City of YUMA

ADDENDUM

DATE: *Monday, December 3, 2012*
TO: *BID NO 2013-20000119 – Police Vehicles - Fully Equipped Utility Package*
FROM: *PURCHASING – Mary Roman*
SUBJECT: *ADDENDUM NO. 3*

ATTACHMENT A

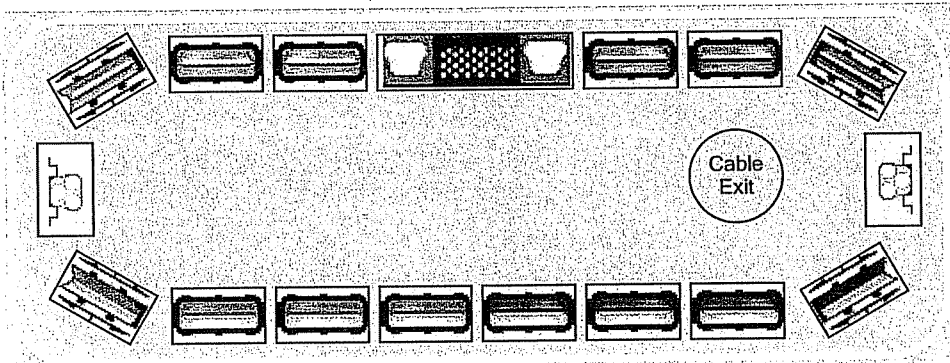
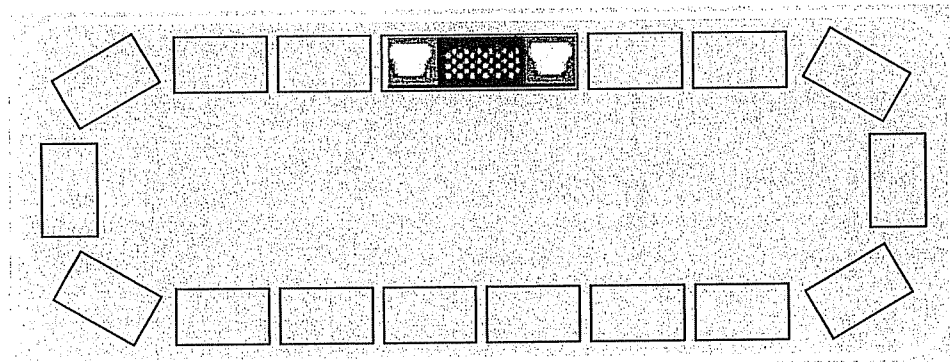
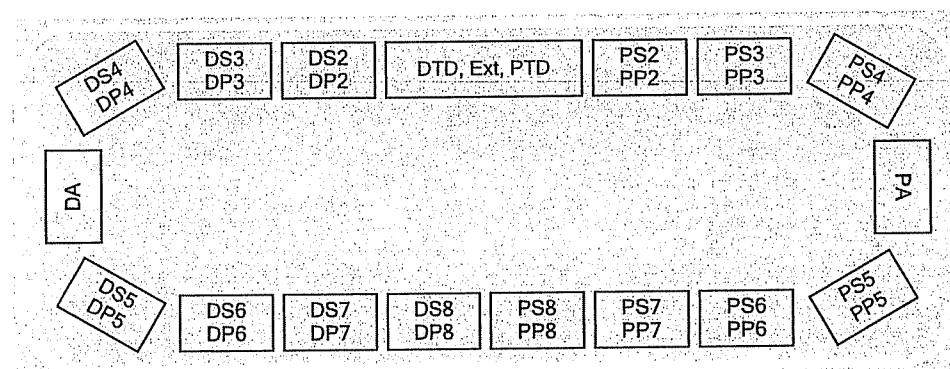
Question #2) Can the City of Yuma provide a light bar drawing? (6.36)

Question #3) Does the City of Yuma want a 48.5 inch or a 54 inch light bar? (6.36)

Answer #2) *Yes, see attachment A.*

Answer #3) *48.5 inch. If submitting an equal light bar should be sized appropriate to fit the bid vehicle without extending past the edge of the roof line and encompass specified warning light package as stated in bid specs.*
